UNITED STATES  
DEPARTMENT OF THE INTERIOR  
BUREAU OF LAND MANAGEMENT

FORM APPROVED  
OMB NO. 1004-0135  
Expires: July 31, 2010**SUNDRY NOTICES AND REPORTS ON WELLS**  
*Do not use this form for proposals to drill or to re-enter an abandoned well. Use form 3160-3 (APD) for such proposals.*5. Lease Serial No.  
NMNM02952B

☒ Oil Well ☐ Gas Well ☐ Other8. Well Name and No.  
JAMES RANCH UNIT 139H2. Name of Operator  
BOPCO LPContact: WHITNEY MCKEE  
E-Mail: wbmckee@basspet.com9. API Well No.  
30-015-39793-00-X1

BOPCO L.P. would like to change plans as attached. The requested changes are due to the original APD being almost two years old. BOPCO, L.P. has implemented multiple changes to the drilling process since this time in order to drill more quickly and economically.

BOPCO  
Project: South East New Mexico

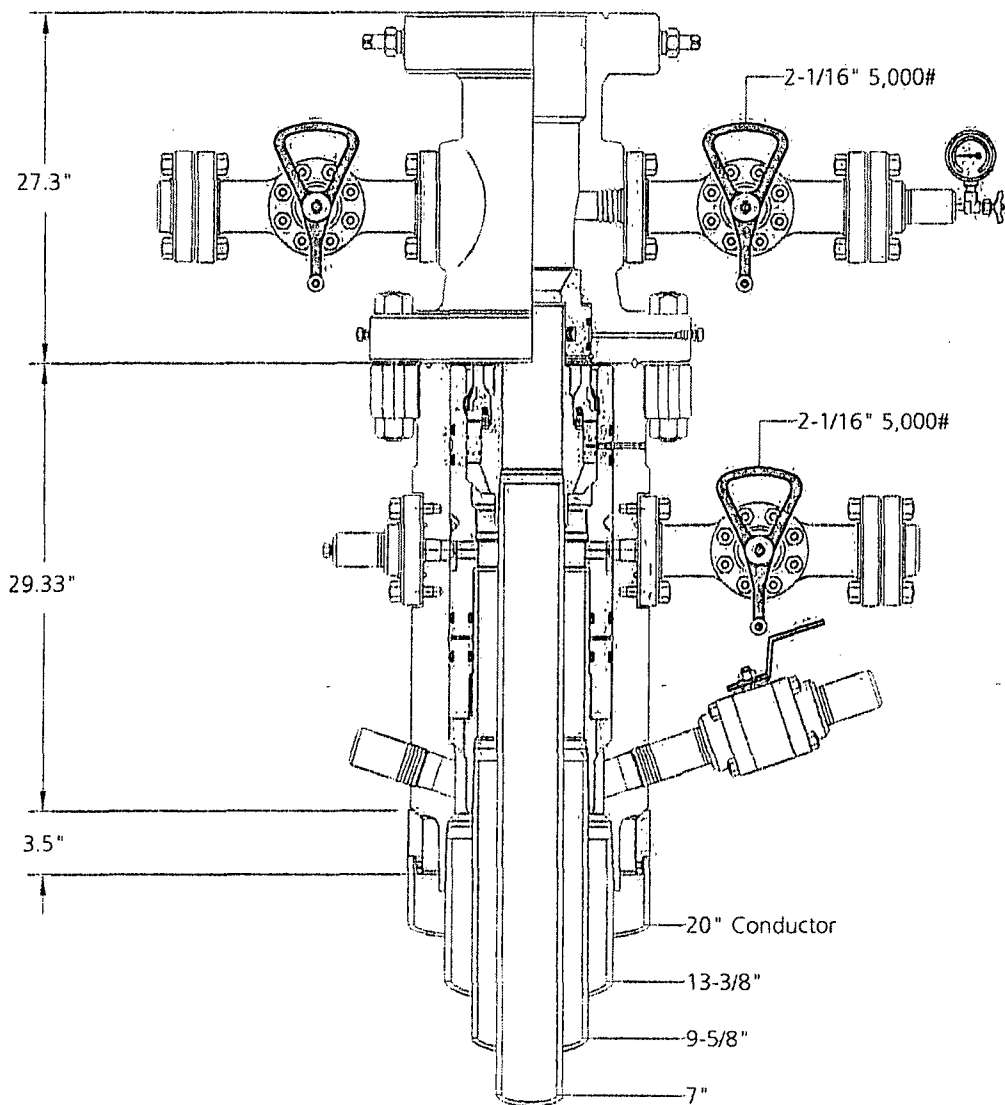
BOPCO, L.P. would like to request a change in plans for BOP testing due to the utilization of the Cameron MB-ND wellhead. We request to nipple up and test BOPE on surface casing to 3,000 psi high and 250 psi low which will cover the testing requirements for the duration of the well. Please find attached the wellhead schematic.

3. **Operator has proposed a multi-bowl wellhead assembly. This assembly will only be tested when installed on the surface casing. Minimum working pressure of the blowout preventer (BOP) and related equipment (BOPE) required for drilling below the surface casing shoe shall be 3000 (3M) psi.**

- a. Wellhead shall be installed by manufacturer's representatives, submit documentation with subsequent sundry.
  - b. If the welding is performed by a third party, the manufacturer's representative shall monitor the temperature to verify that it does not exceed the maximum temperature of the seal.

- c. Manufacturer representative shall install the test plug for the initial BOP test.
  - d. Operator shall perform the 9-5/8" and 7" casing integrity tests to 70% of the casing burst. This will test the multi-bowl seals.

## Internal Hydrostatic Test Graph

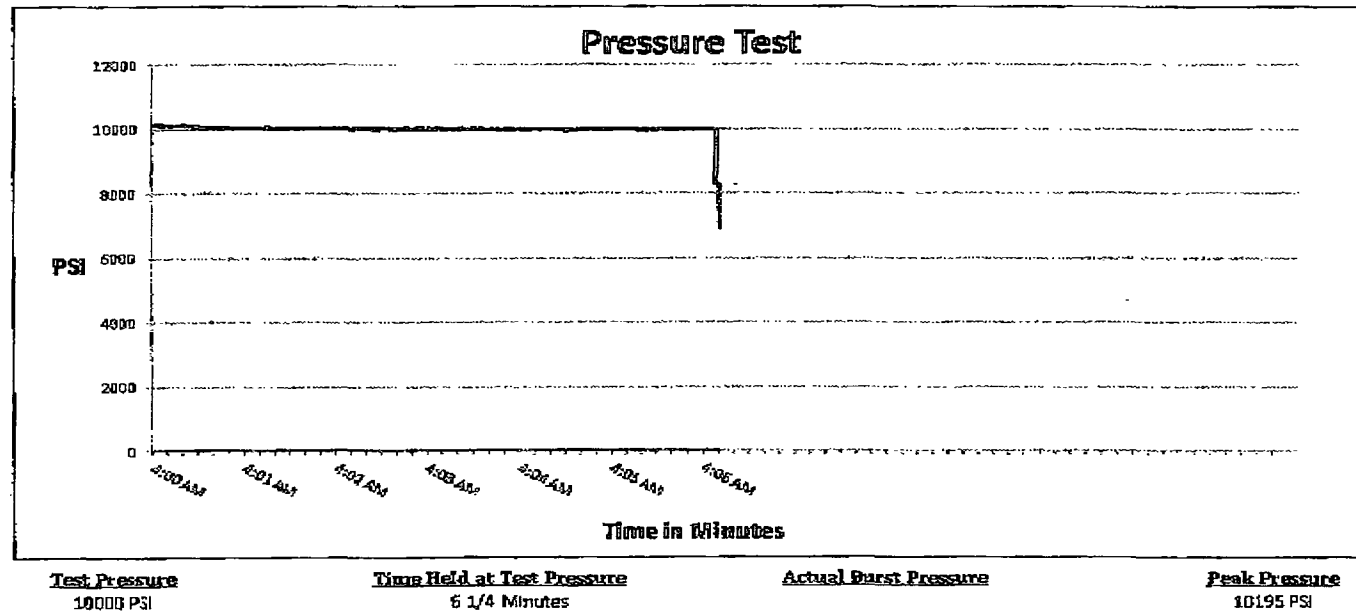
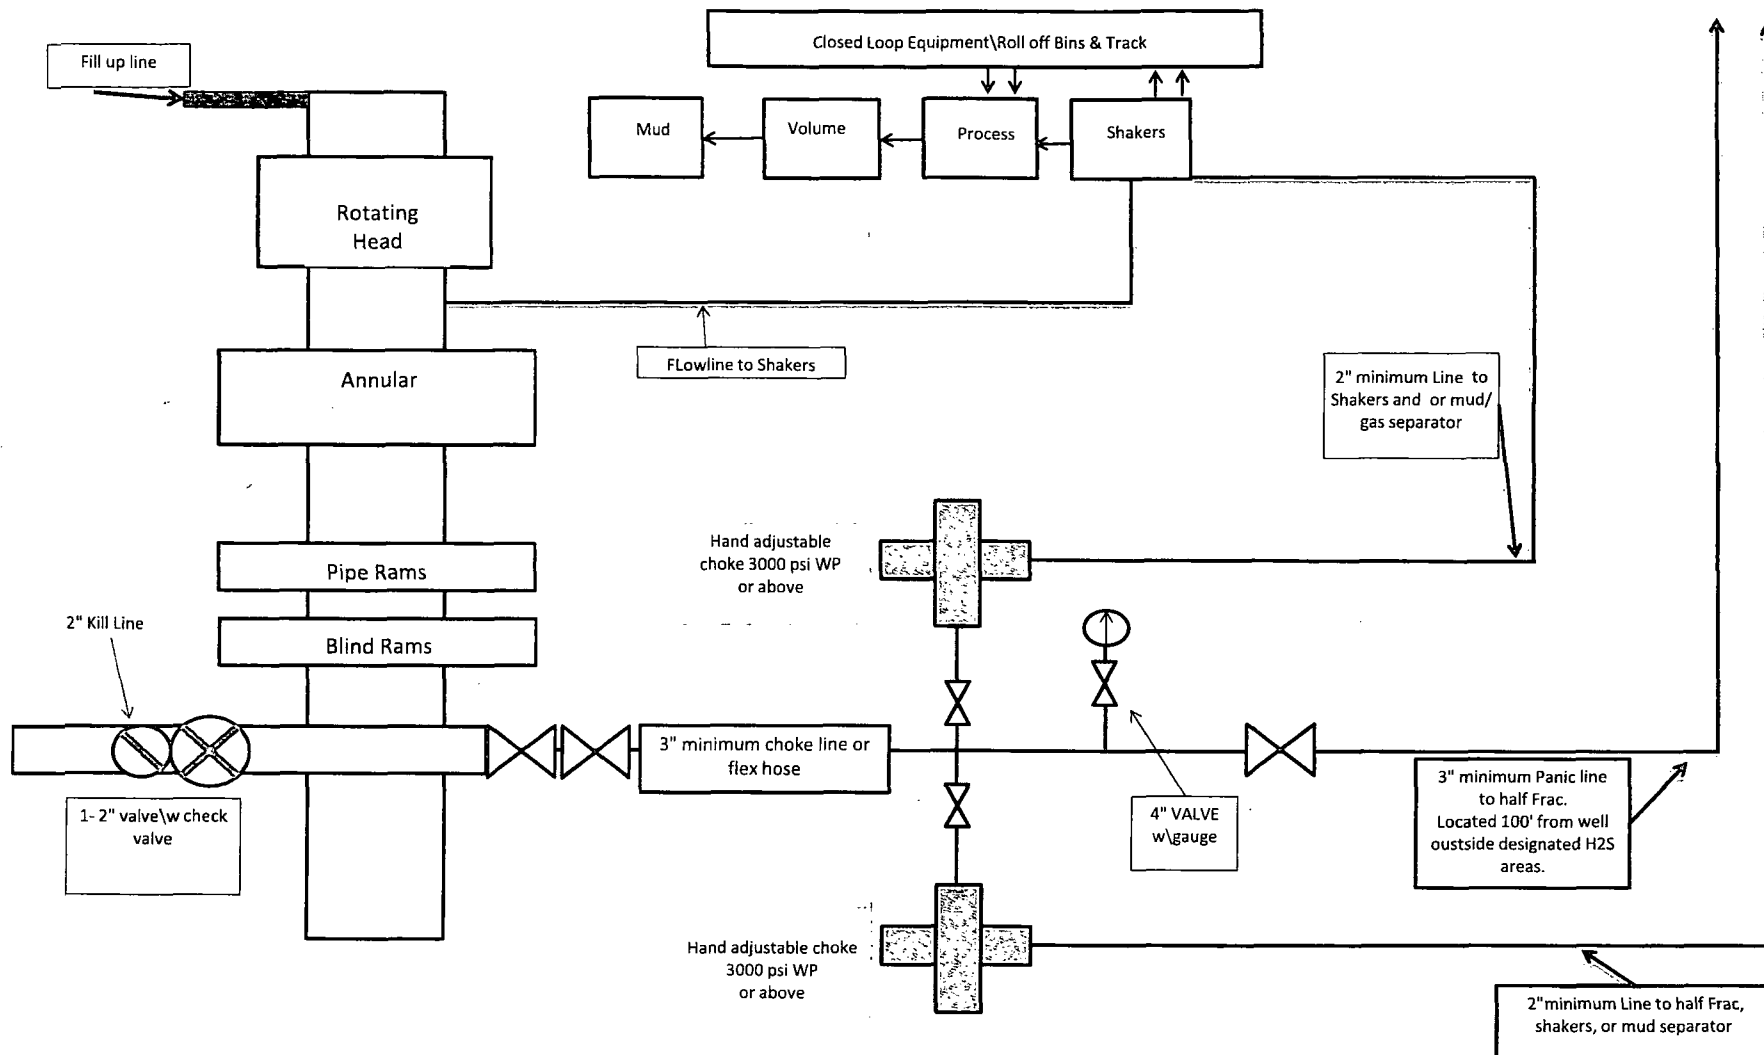
BOPCO, L.P. would like to request a variance to use an armored, 3", 5000 psi WP flex hose for the choke line in the drilling of the well. (See specification for hose that might be used, attached with APD exhibits). This is rig equipment and will help quicken nipple up time thus saving money without a safety problem. The hose itself is rated to 5,000 psi, and has 5,000 psi flanges on each end. This well is to be drilled to approximately 19,596' MD (7,343' TVD) and max surface pressure should be +/- 1,897 psi as prescribed in Onshore Order #2 shown as max BHP minus 0.22 psi/ft. Thus, 3000 psi BOPE is all that is needed for this well. Please refer to diagrams A, B, or C for choke manifold and closed loop system layout. If an armored flex hose is utilized, the company man will have all of the proper certified paper work for that hose available on location.

2. Variance approved to use flex line from BOP to choke manifold. Check condition of flexible line from BOP to choke manifold, replace if exterior is damaged or if line fails test. Line to be as straight as possible with no hard bends and is to be anchored according to Manufacturer's requirements. The flexible hose can be exchanged with a hose of equal size and equal or greater pressure rating. **Anchor requirements, specification sheet and hydrostatic pressure test certification matching the hose in service, to be onsite for review. These documents shall be posted in the company man's trailer and on the rig floor.** If the BLM inspector questions the straightness of the hose, a BLM engineer will be contacted and will review in the field or via picture supplied by inspector to determine if changes are required (operator shall expect delays if this occurs).
